UNITED STATES PATENT AND TRADEMARK OFFICE

APPLICATION NO.	FILING DATE	FIRST NAMED INVENTOR	ATTORNEY DOCKET NO.	CONFIRMATION NO
10/602,784	06/24/2003	Basil C. Linton	ITW-13971	1672
44702	7590 06/07/2005		EXAMINER	
	CHONG FLAHERT	HYLTON, ROE	BIN ANNETTE	
250 PARK AVENUE, SUITE 825 NEW YORK, NY 10177			ART UNIT	PAPER NUMBER
			3727

DETAILED ACTION

FIG.3

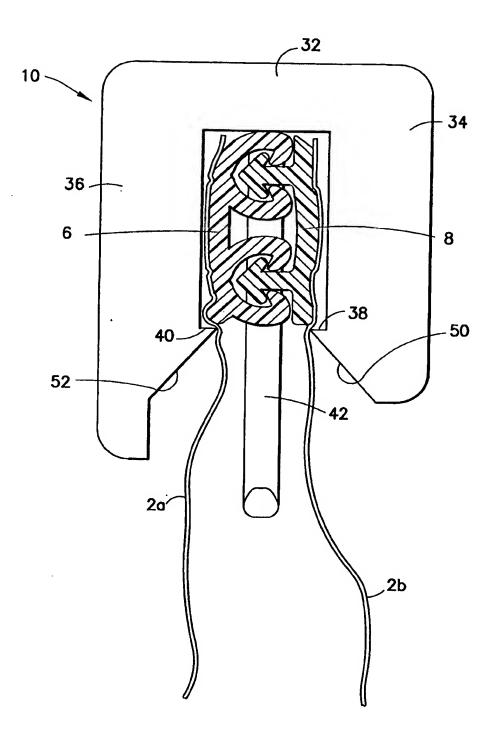
- 1. The drawings were received on March 25, 2005. These drawings are approved in part. The corrections to figure 3 is accepted. The changes to figure 1 introduces new matter since there is no support in the disclosure as originally filed to depict the slits with having the orientation illustrated. In fact, there is no disclosure for any length or orientation of the slits. Figure 1 is not approved.
- 2. In order to avoid abandonment, the drawing informalities noted in paragraphs 3 and 4 (relating to the slits) in the paper mailed on December 16, 2004, must now be corrected.

Correction can only be effected in the manner set forth in the above noted paper.
